**NATIONAL ELECTRICAL CODE®
CODE-MAKING PANEL 3
NFPA 70
Second Draft Meeting Agenda
October 29 – November 3, 2018
San Diego, CA**

Attachment A: Previous Meeting Minutes

Attachment B: Public Comment Report

**Public Comment No. 280-NFPA 70-2018 [Section No. 300.3(B)(1)]****(1) Paralleled Installations.**

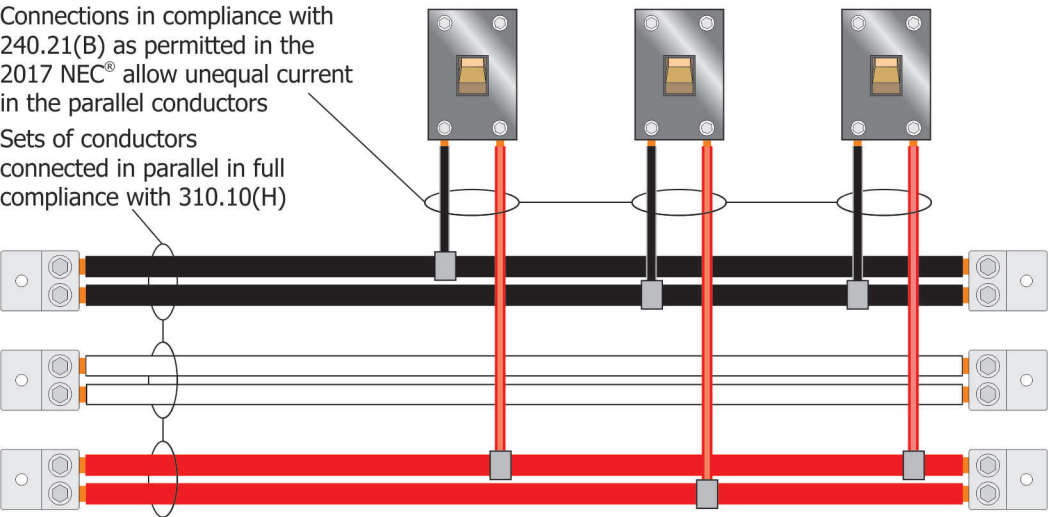
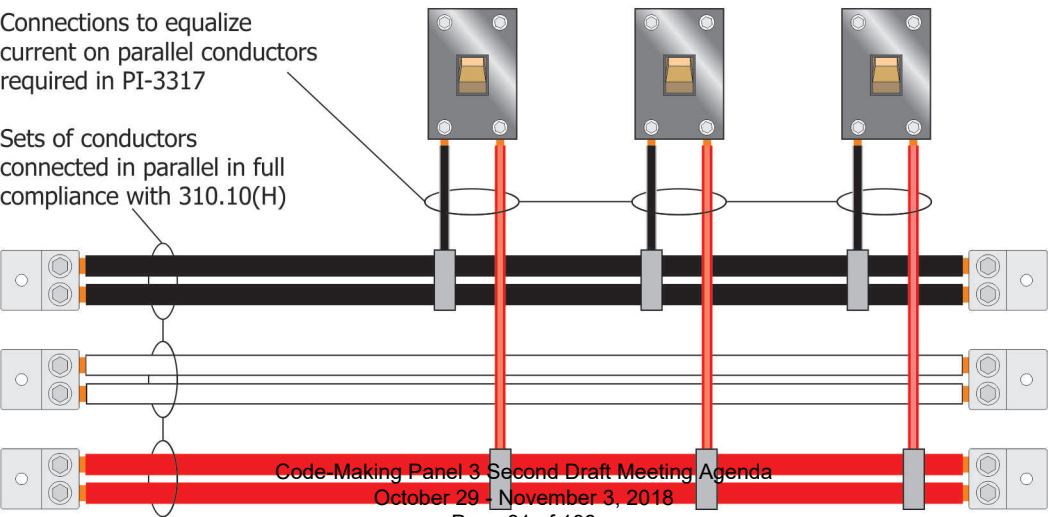
This proposed change is important to ensure safety and should be accepted.

Connections typically made in a wireway or auxiliary gutter.

Connections to equalize current on parallel conductors required in PI-3317

Sets of conductors connected in parallel in full compliance with 310.10(H)

Connections typically made in a wireway or auxiliary gutter.

Figure 725.154(A) Cable Substitution Hierarchy.

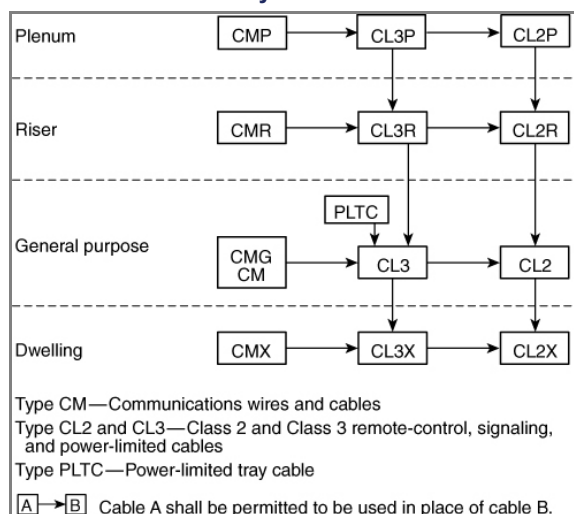
The substitutions for Class 2 and Class 3 cables listed in Table 725.154(A) and illustrated in Figure 725.154(A) shall be permitted. Where substitute cables are installed, the wiring requirements of Article 725, Parts I and III, shall apply.

Figure 760.154(A) Cable Substitution Hierarchy.

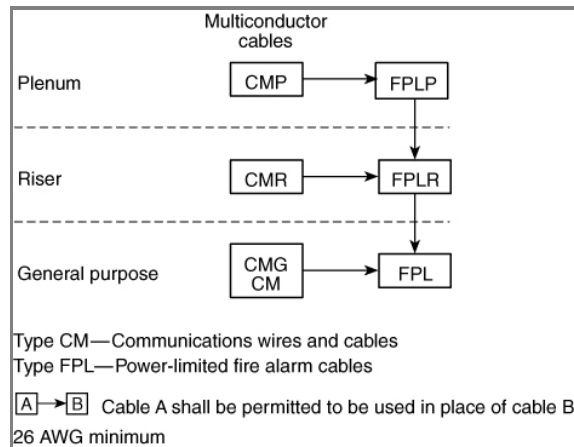
The substitutions for fire alarm cables listed in Table 760.154(A) and illustrated in Figure 760.154(A) shall be permitted. Where substitute cables are installed, the wiring requirements of Article 760, Parts I and III, shall apply.
